**MAJOR PROJECT ASSESSMENT:
8B Murray Rose Avenue
Sydney Olympic Park
MP10_0214**

Director-General's
Environmental Assessment Report
Section 75I of the
Environmental Planning and Assessment Act 1979

September 2011

Figure 16: Public Domain Interface Plan (extract)

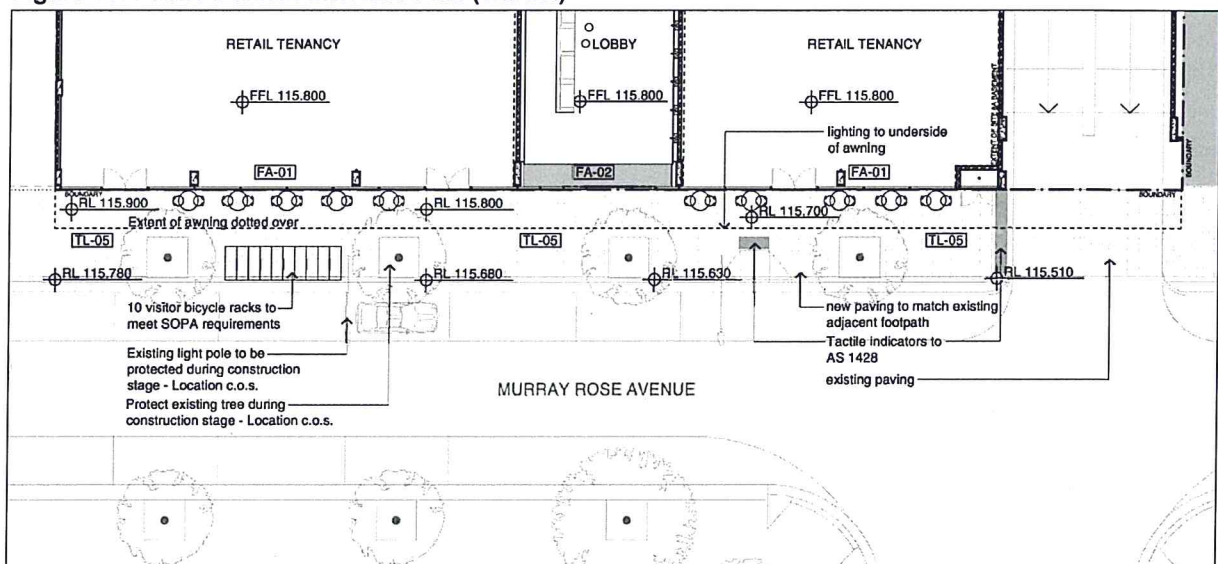
During the exhibition of the proposal, SOPA requested the submission of a Public Domain Interface Plan (PDIP) to demonstrate that external public domain works and finished levels are satisfactory and match existing works adjacent. Accordingly, the proponent provided a PDIP that details the proposed treatment of the public domain fronting the site and finished footpath levels that coordinate with the proposed internal finished floor levels of the retail and lobby floor areas (see Figure 16). No other landscaping or public domain works are proposed.

SOPA also raised concern during the exhibition that the proposed 2m wide awning was unsatisfactory and was required to be a minimum 3m in width in accordance with SOP Master Plan 2030. Within the PPR, the proponent noted that the adjoining development at Site 8A was approved with a 2m wide awning and that the proposed width would provide better continuity within the streetscape. Further, the proposed 2m wide awning would reduce potential impact on existing street trees.

The department considers the proposed 2m wide awning to be satisfactory, providing a uniform edge to the streetscape and sufficient shelter from rain when required.

Figure 18: Existing Shared Vehicle Entry/Exit

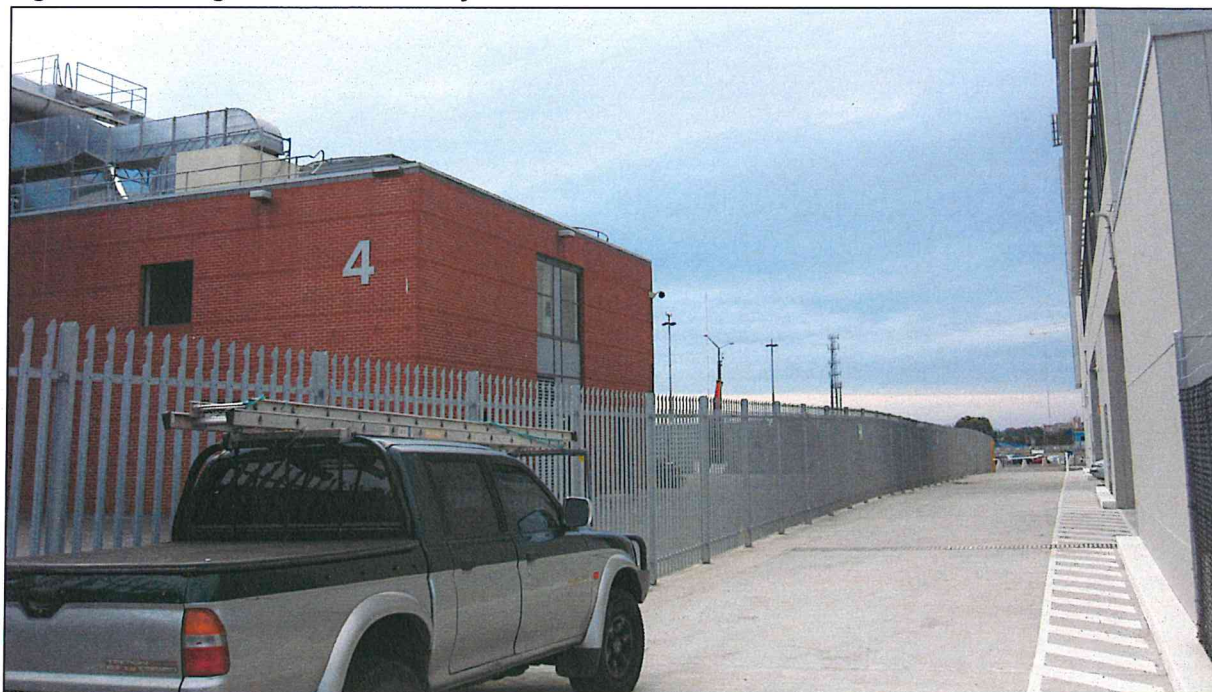
It is also a requirement of the Site Deed that removable fencing is installed along the common boundary of Site 8 and the adjoining RAS site after the completion of each stage of works on Site 8. Boundary fencing currently exists along the right-of-way between the Site 8A and the RAS (see Figure 18). The removable fencing is permitted to be removed during the Royal Easter Show period and is then required to be re-installed at the end of the period.

The department recommends that the CMP be prepared in consultation with SOPA to ensure that satisfactory arrangements are made, particularly staging of construction works, to ensure that the rights of benefited users of the existing right-of-way are maintained.

Figure 1: Shadow Diagrams - Winter Solstice

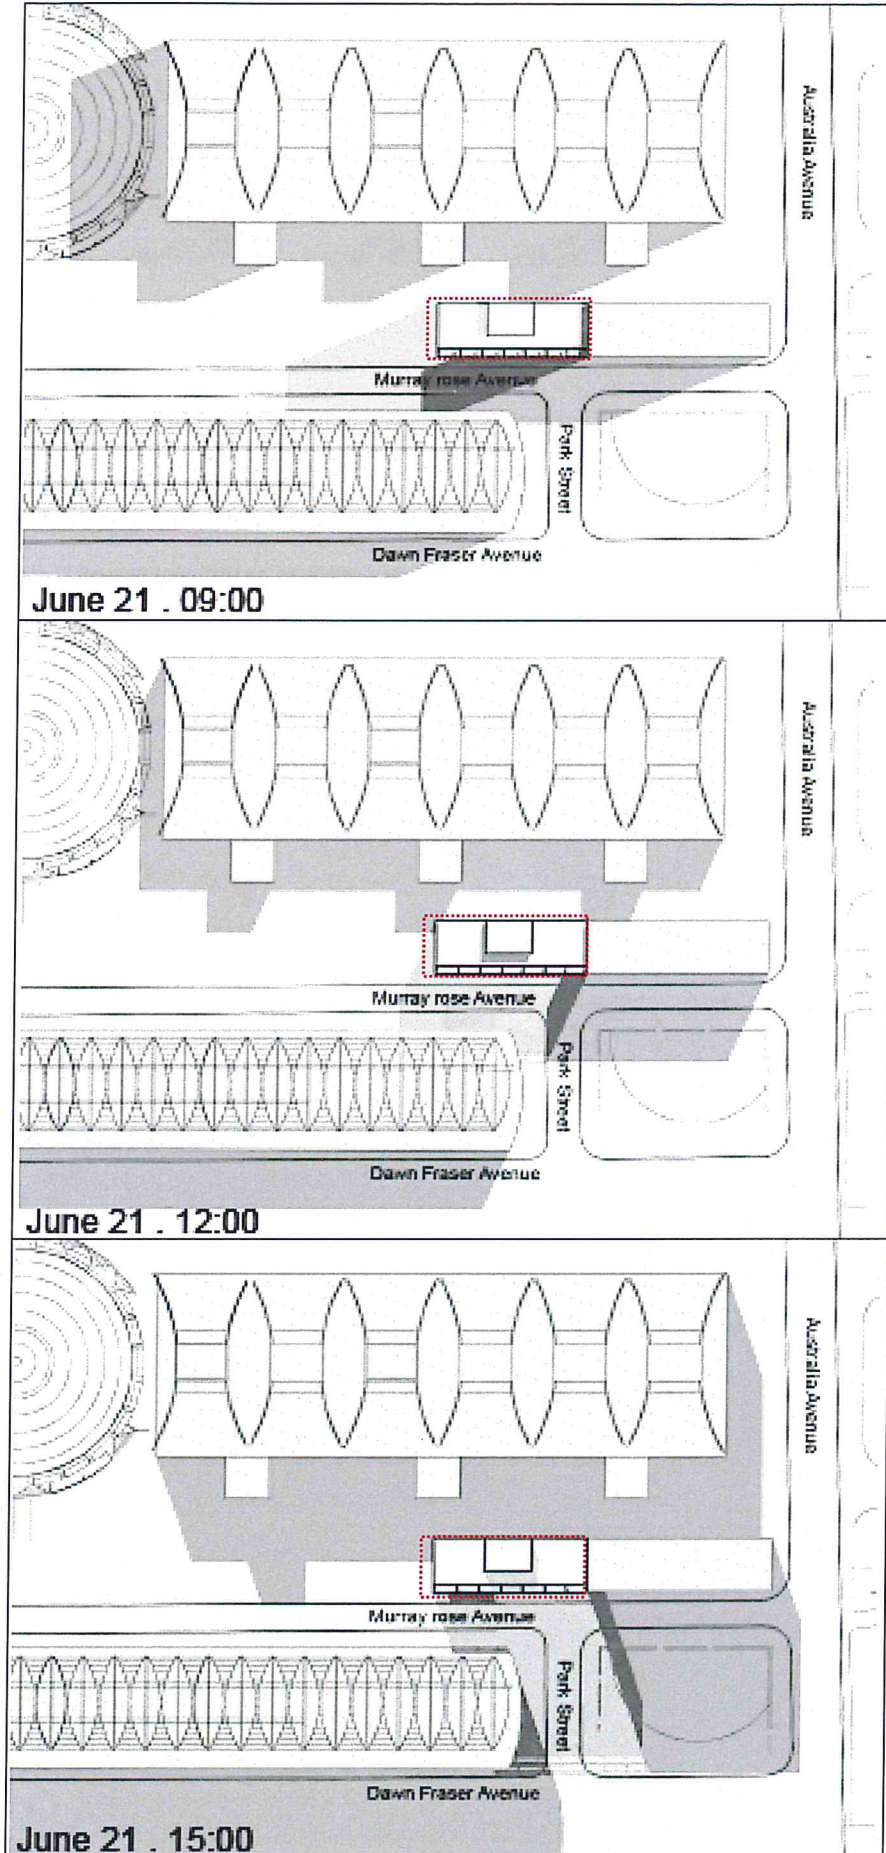
The extent of overshadowing generated by the proposed development during the winter solstice would be minor, with Site 8A generating the most impact, particularly on Jacaranda Square (see Figure 1). The difference between the impacts likely to be generated by the proposal and an FSR compliant proposal would be negligible. In this respect, the proposal's height, bulk, scale and overshadowing impacts are comparable with the existing and future surrounding built form. The proposal is consistent with the key controls outlined within the SOP Master Plan 2030, including the maximum building height, floor to ceiling heights, 90% build to line setback requirement to ensure that the proposed facade reinforces the street alignment.
